- 6. Sleepy Hollow Subdivision 2024 Addition**  
**KPB File 2024-085**  
**Johnson Surveying / Villa**  
**Location: Alma Avenue & Van Dyke Street**  
**Sterling Area**

# Sleepy Hollow Subdivision 2024 Addition Preliminary Plat

**ITEM 6 - PRELIMINARY PLAT  
SLEEP HOLLOW SUBDIVISION 2024 ADDITION**

<b>KPB File No.</b>	2024-085
<b>Plat Committee Meeting:</b>	September 9, 2024
<b>Applicant / Owner:</b>	Alexander E & Annette B Villa of Sterling, Alaska
<b>Surveyor:</b>	Jerry Johnson / Johnson Surveying
<b>General Location:</b>	Alma Avenue & Van Dyke Street, Sterling

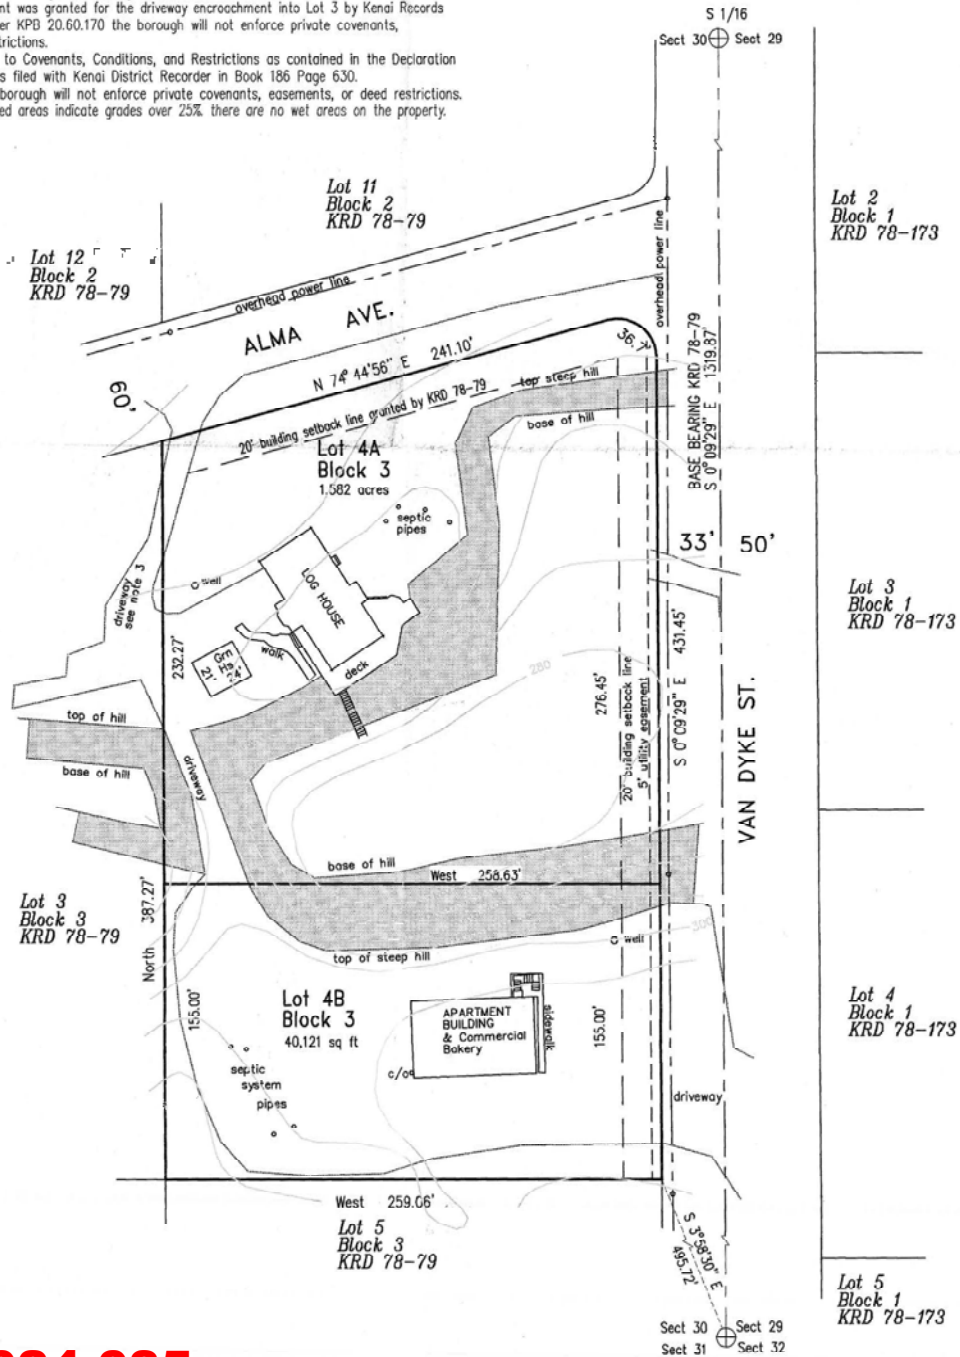
There is a private right-of-way access easement for ingress and egress affecting Lot 4A, Block 3, noted as plat note #3 onto Lot 3 to the west. Remove the covenant note in the second sentence of plat note #3 as this is not a covenant. Note on drawing should be more prominent.

There is steep terrain shown on the plat with grades over 25% shaded. Contours can be removed for the final submittal, but the shading of the steep areas should remain.

The parent plat, Sleepy Hollow Subdivision, KN 78-79, granted a 5-foot utility easement along Van Dyke Street. The proposed plat grants a 10-foot utility easement adjoining all rights-of-ways and should be shown on the plat. the 5' utility easement can be removed on the drawing and can remain as a plat note being carried forward from the parent plat.

- Remove from plat note number 3, the portion regarding KPB 20.60.170.

*Correct the range in the legal description.*

*Correct the owner's mailing address to reflect KPB records.*

Add the KPB File number 2024-085 to title block.

*Correct the spelling of Fannie Mae Avenue.*

*Move Soldotna city limits label to the South to reflect location more accurately.*

*Label southwest lot 6, block 3, KN 78-79.*
